**CITY OF FLORENCE  
PLANNING COMMISSION**

**RESOLUTION PC 15 03 CUP 02**

**A REQUEST FOR A CONDITIONAL USE PERMIT TO PLACE AN 84FT. BY 64 FT. MODULAR BUILDING WITH FIVE CLASSROOMS TO SERVE AS THE KINDERGARTEN FACILITY FOR THE SCHOOL DISTRICT IN THE MULTI-FAMILY RESIDENTIAL DISTRICT.**

**Hearing Date:** March 24, 2015  
**Date of Report:** March 17, 2015  
**Application:** PC 15 03 CUP 02

Proposed Site And Utility Plan

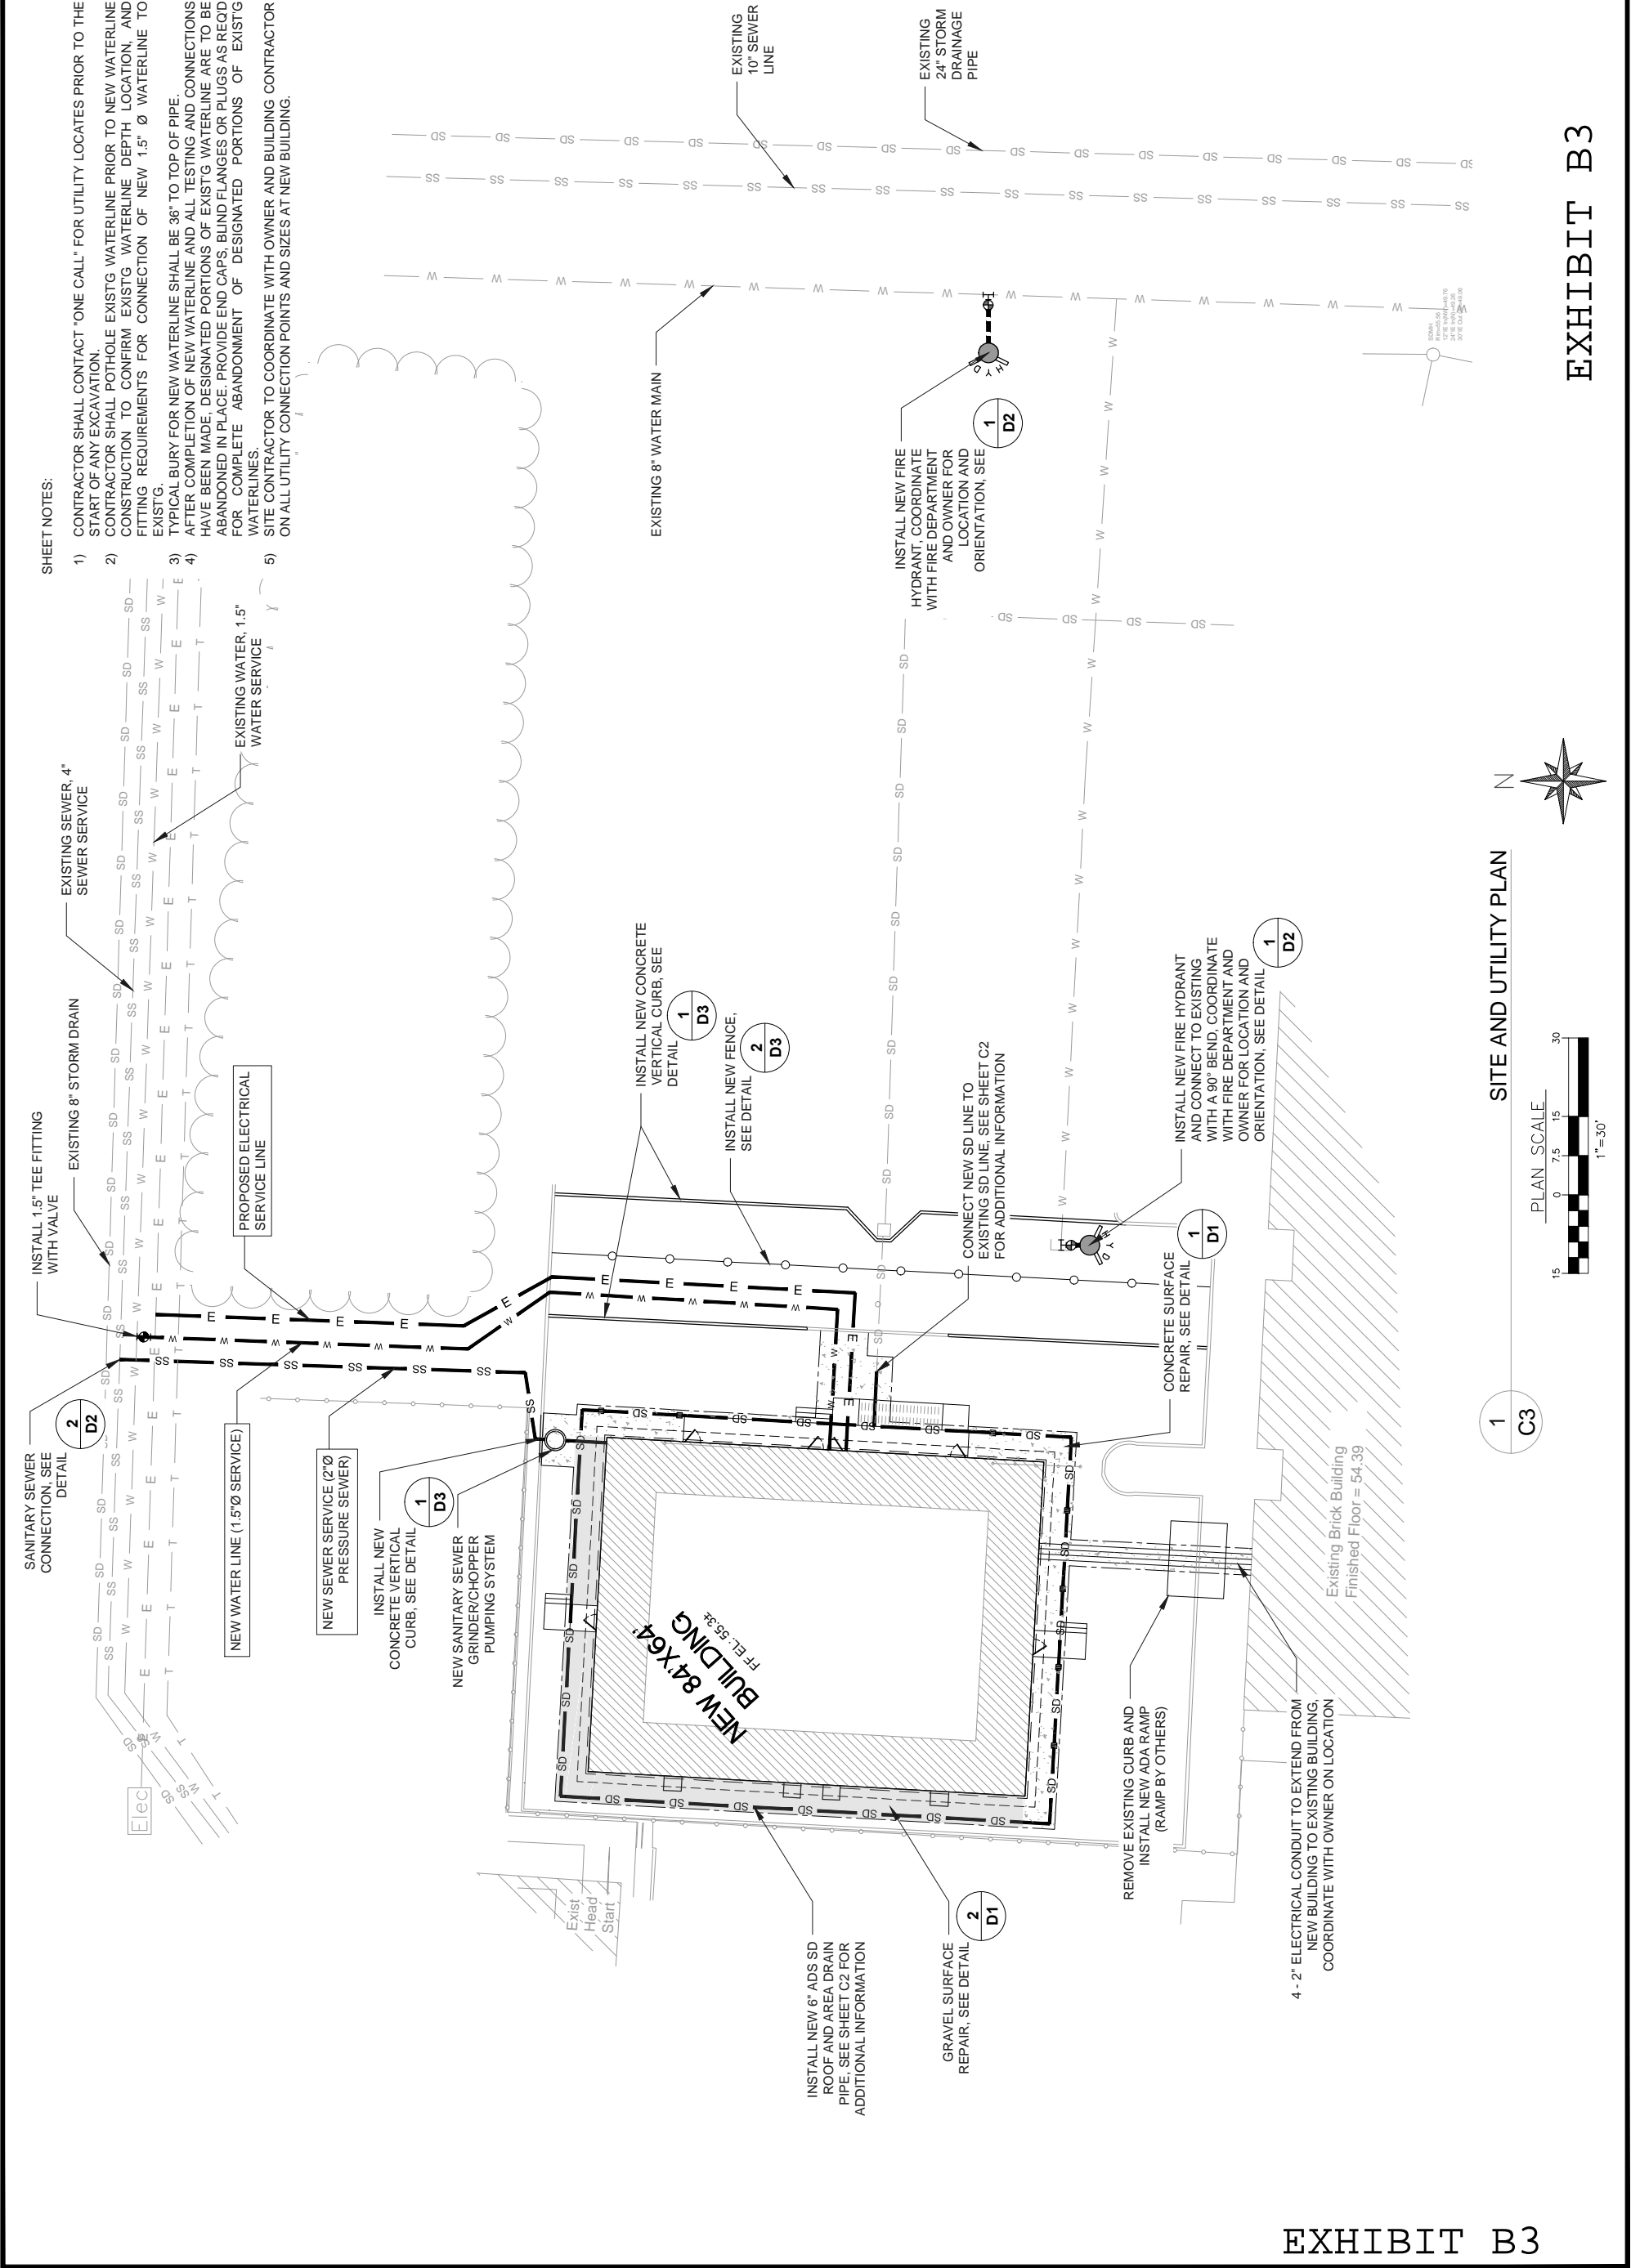
No changes are proposed for the existing parking space grading design. The existing catch basin located in the center of the proposed building pad is proposed to be relocated east of the proposed chain link fencing and just west of the parking lots. This criterion is met.

**Finding:** The applicant proposes to replace curbs within the areas along the northern internal property line. Curbing is also proposed along the eastern project between the modular and the eastern parking. No sidewalk area is subject to encroachment. A 5' landscape buffer is present between parking in the northern lot and Oak St. These criteria are met.

**TYPICAL FENCE DETAILS**  
NOT TO SCALE

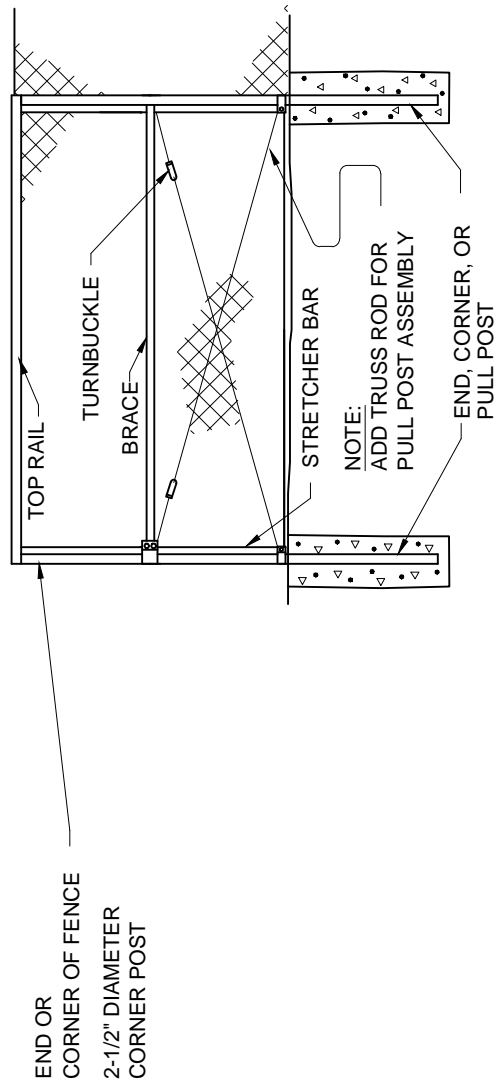
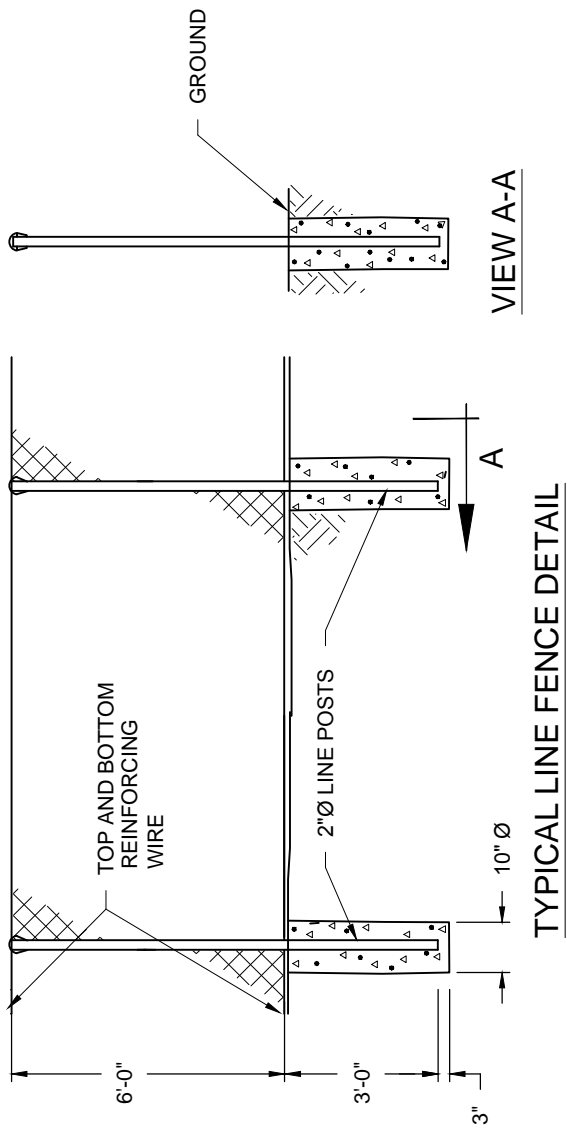
**Finding:** The applicant proposes a north south running fence between the building and the new western edge of the easterly parking lot. It will be 6' high chain link. The 10-34 criteria are met.
